# UNIVERSITY OF KENTUCKY Purchasing Division

CCK-2632-22

ADDENDUM# 2

**UK Reynolds Building #1 College of Design  
BID PACKAGE - 01  
ADDENDUM No. 2  
CCK-2632-22  
05/25/2022**

**WINDOW TYPES:**

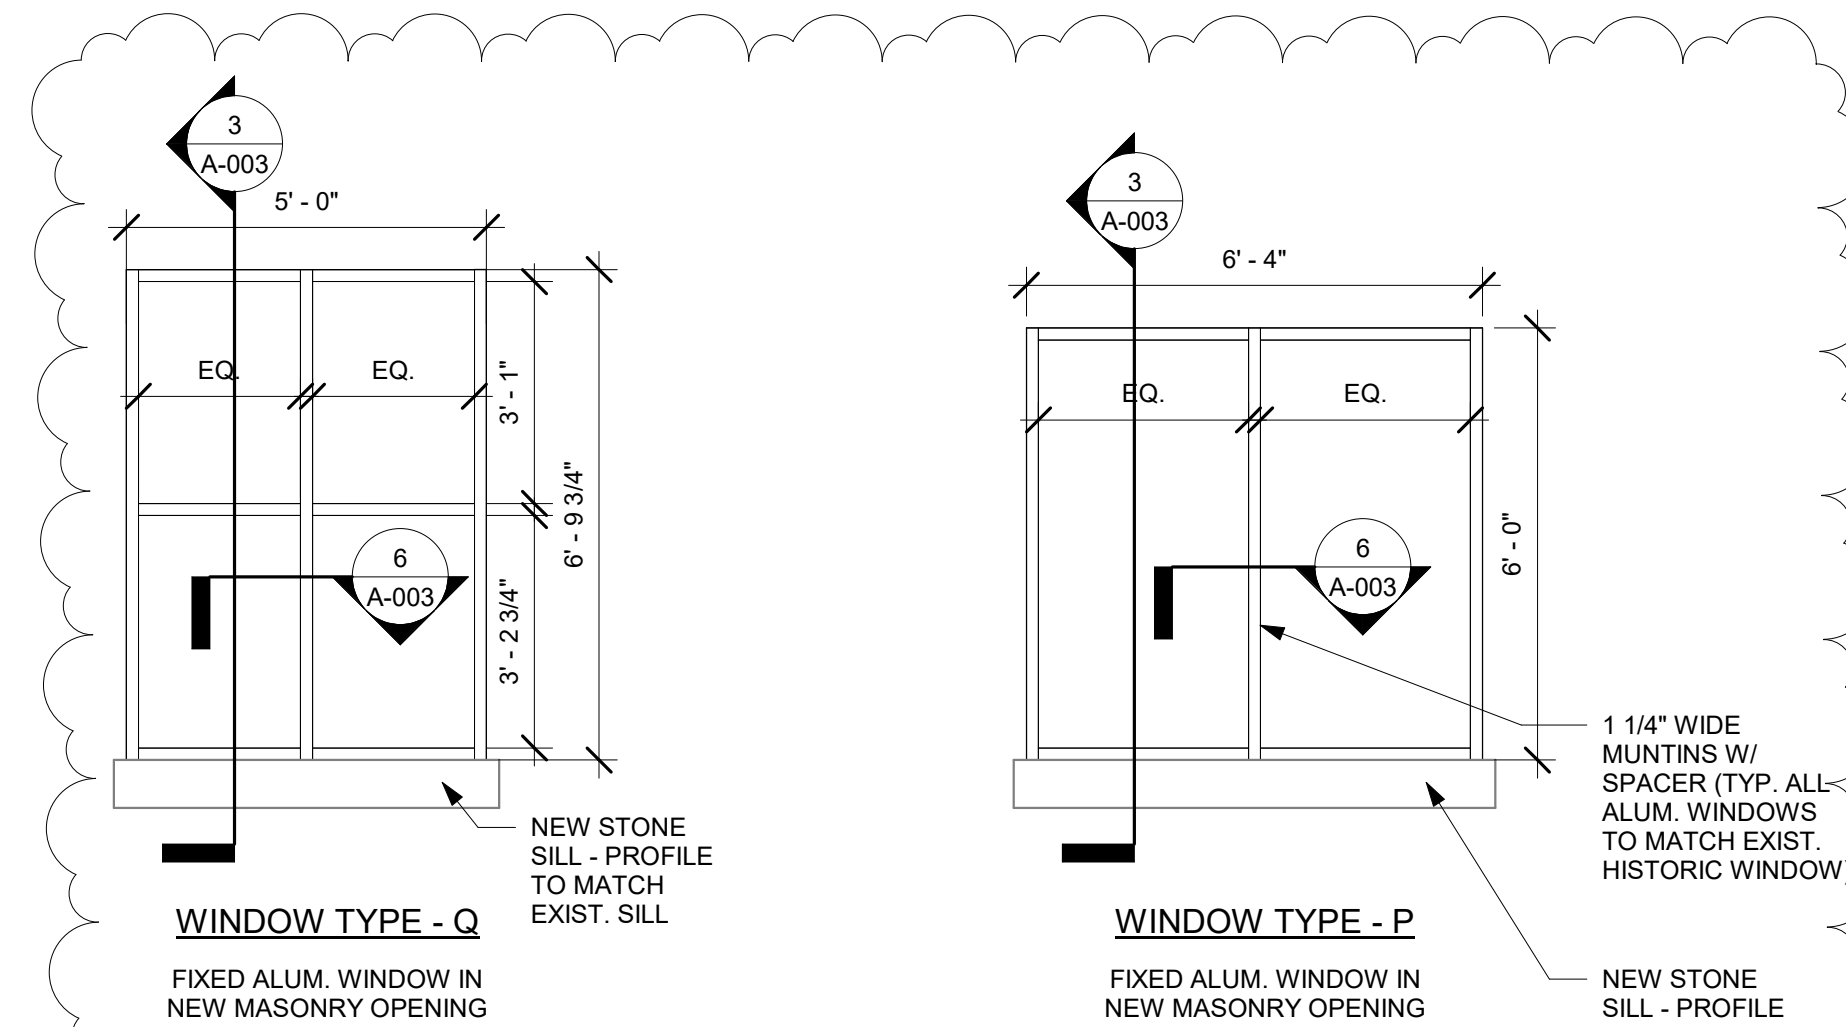
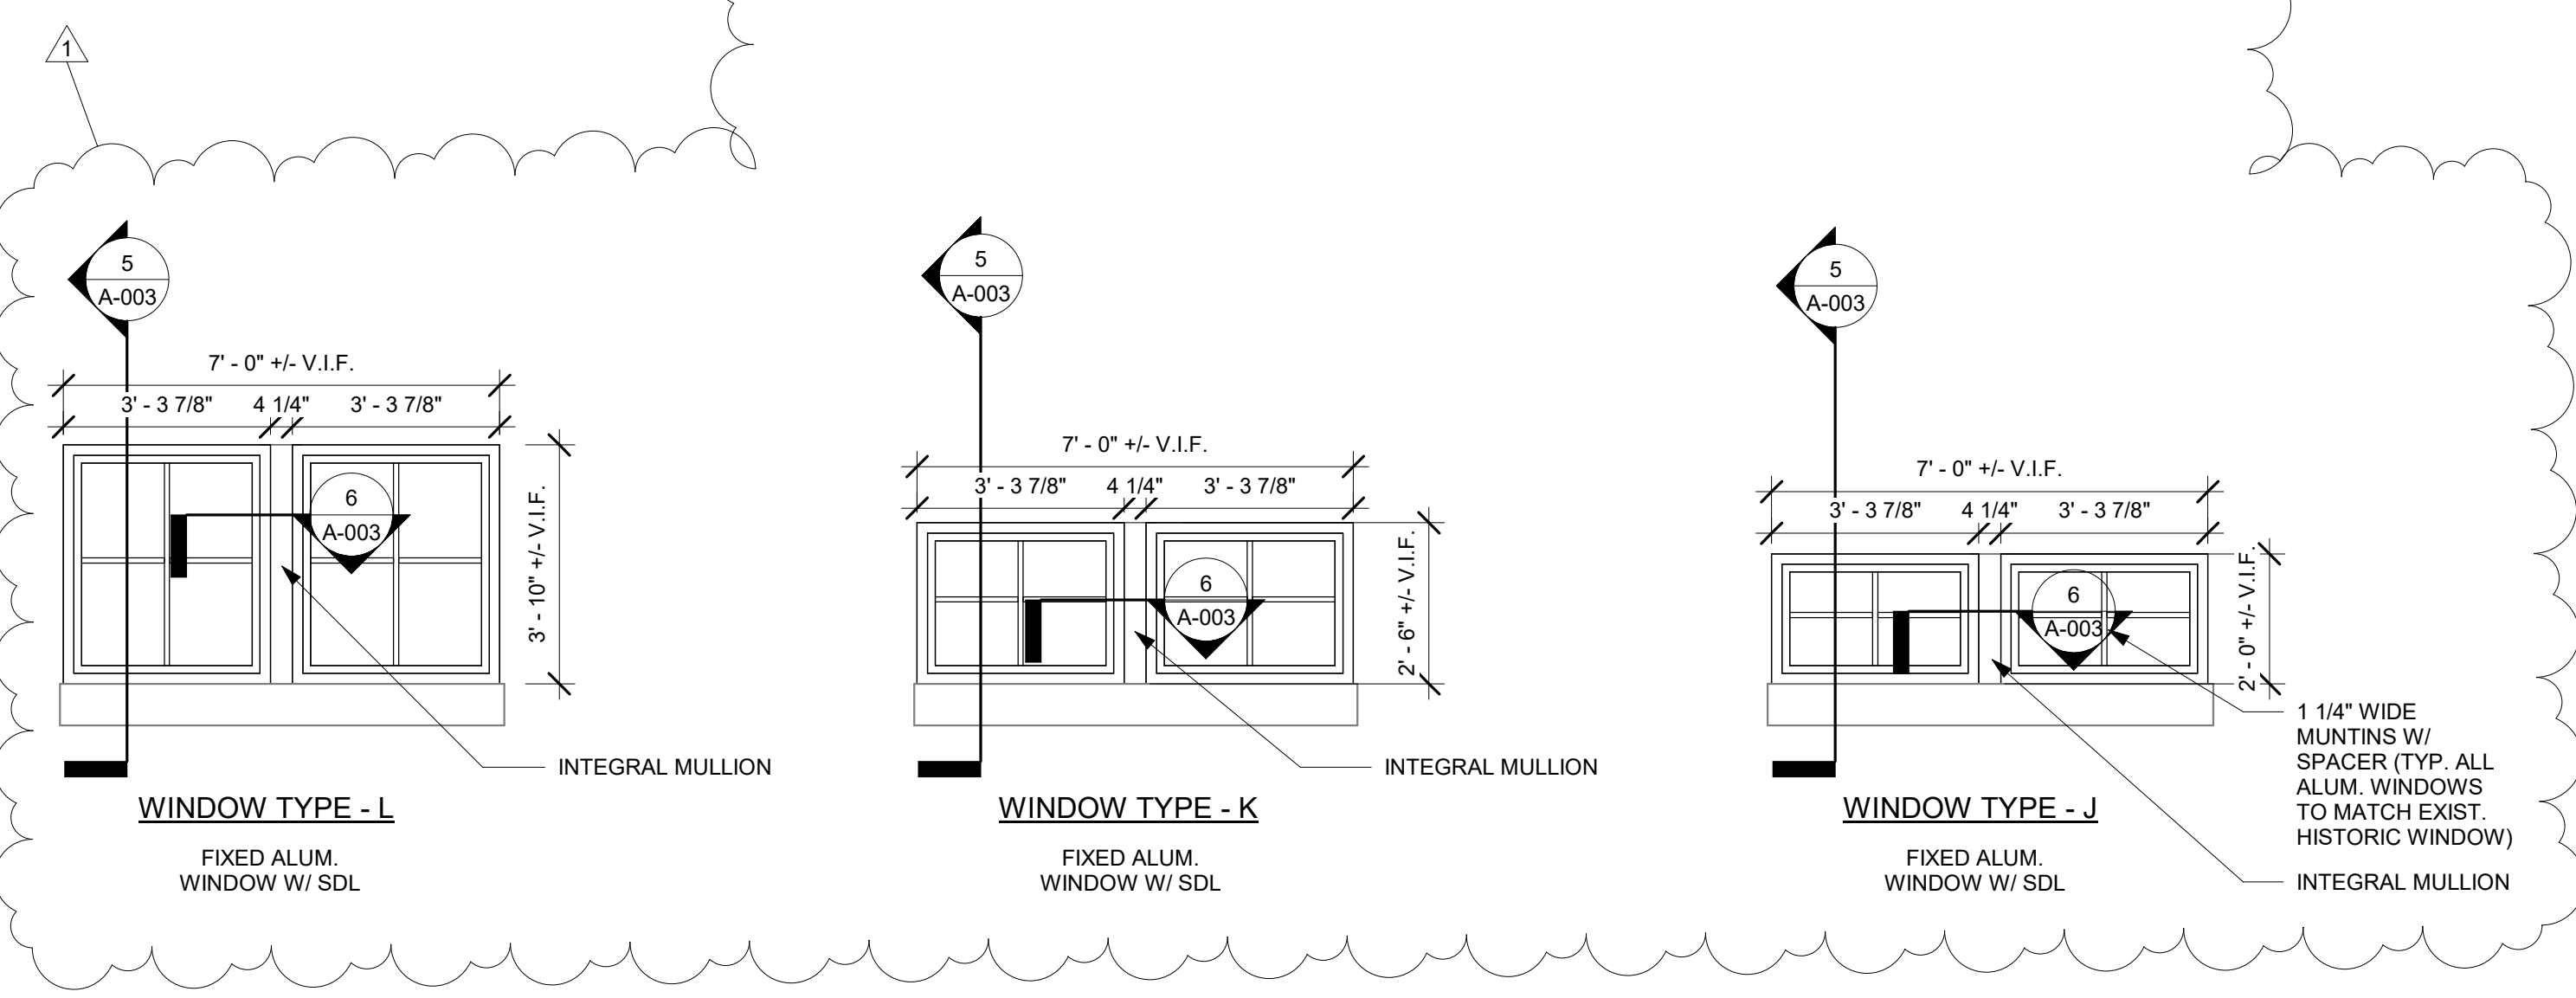
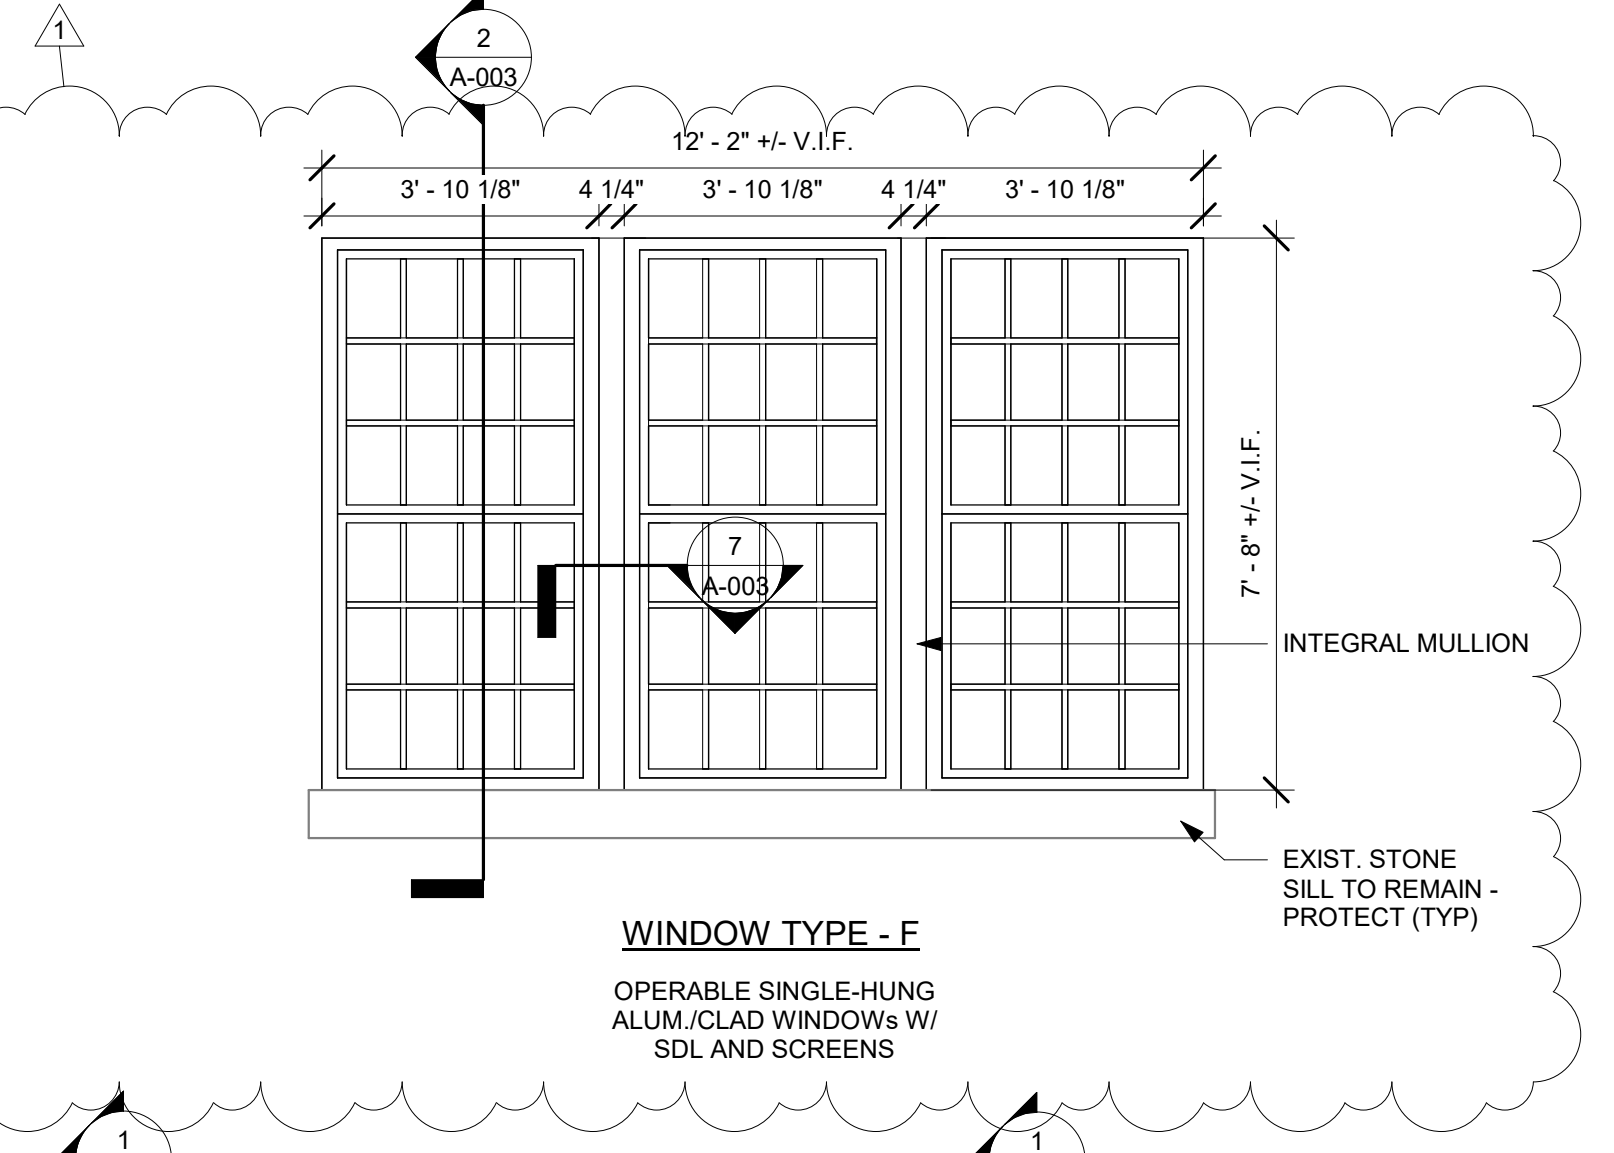
3. Sheet A-001 – Wall Types, door & Frame Types & Details: See amended sheet (attached) to add Frame Type “H” for Doors 114J.3 and 114H
4. Sheet A-002 – Exterior Window Types (attached):

- a. Revise lettering nomenclature of select windows.
    - i. Add Window “M” (located on Broadway (West) elevation, and is similar to J, K, and L)
    - ii. Change window types M1 and M2 to type “P” and “Q”. Windows are in new masonry openings, at the East wall overlooking the Maker Yard. See attached sheets A-306 and A-307 for reference and revised tags. Revise floor plans accordingly.

- b. Window Types “J”, “K”, “L”: revise head & sill section detail tag to 05/A-003. See new vertical muntin detail, 06/A-003.

- c. Window operability: All single-hung windows are to be provided with operable function, that can be optional with custodial sash locks. Delete “FIXED” single-hung references for Types A and B. These shall be optionally operable.

**SECTION D**  
S-410  
1/8" = 1'-0"

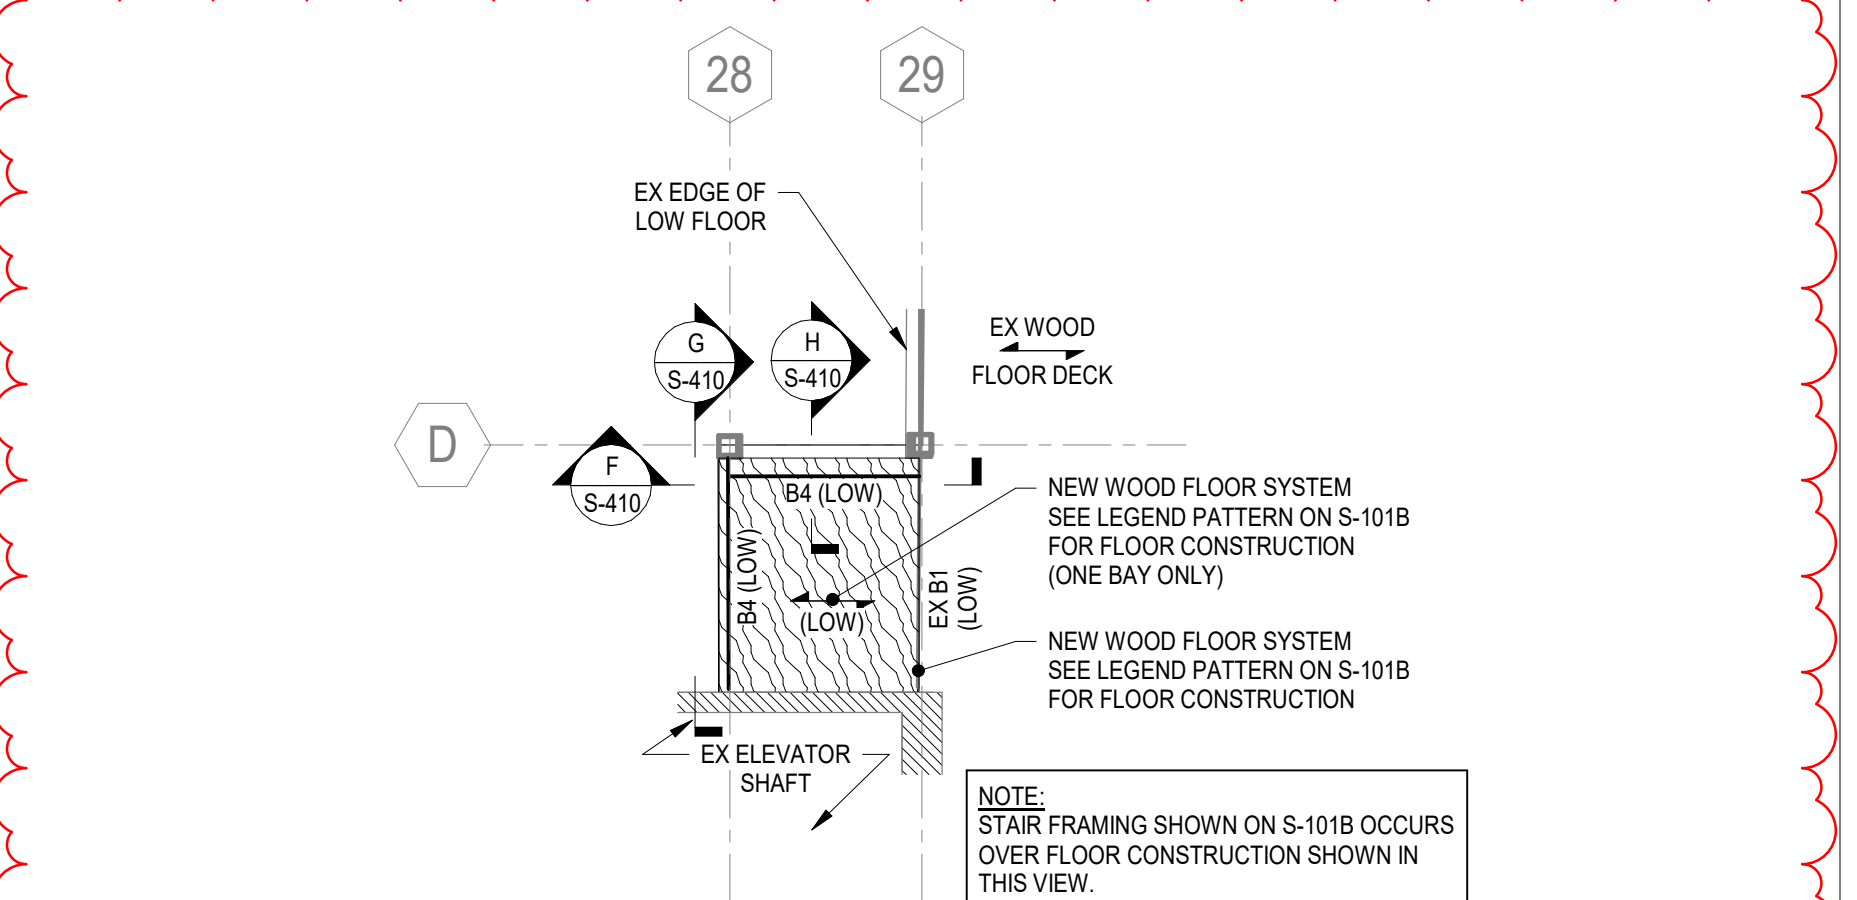
Refer to sheet S-101B: At stair adjacent to existing elevator shaft, add callout reference to D/S-410 as shown below. This plan detail shows new beam and floor construction required below the stair.
